The Fuel Pump Modules of XJR-S vehicles were changed in production at VIN 187460.

Upgrade XJR-S vehicles with the revised Fuel Pump Modules as necessary.

Service Action S385

ILLUSTRATION 1

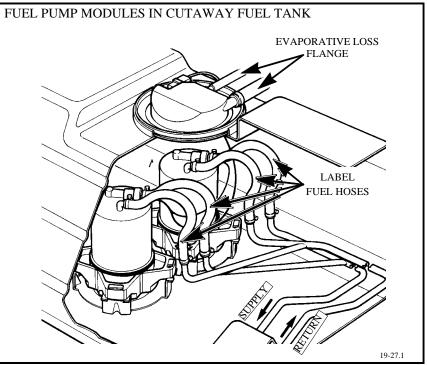
6. Label, and remove the fuel supply and return hoses from the fuel pump modules.

ILLUSTRATION 3

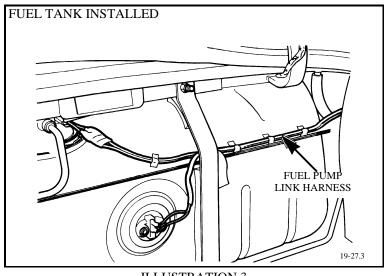
- 12. Align the module and mounting rubber location lugs, seat the modules into the mounting rubbers and install new tie straps.
- 13. Fit the module/mounting rubber assembly to the fuel tank base and reconnect the fuel feed and return hoses. Tighten the hose clamps with tool JD 175.
- 14. Install the new evaporative loss flange and sealing ring.
- 15. Remove the original fuel tank part number label and affix the modified fuel tank part number label in its place.
- 16. Reinstall the fuel tank using the new fuel line and "O" rings for the new filler neck gaiter.
- 17. Remove and discard the vent pipe from the old evaporative flange and replace the trunk floor grommet with the new blanking plug,
- 18. Remove the fuel pump link harness from the chassis harness and replace with the new link harness.

- 19. Install the new 25 amp fuel pump fuse and replace the existing fuse label with the new one.
- 20. Reinstall the battery and trunk interior panels. Program the preset radio stations and reset the clock.
- 21. Clean the left rear underside corner of the hood panel and affix the S385 label.
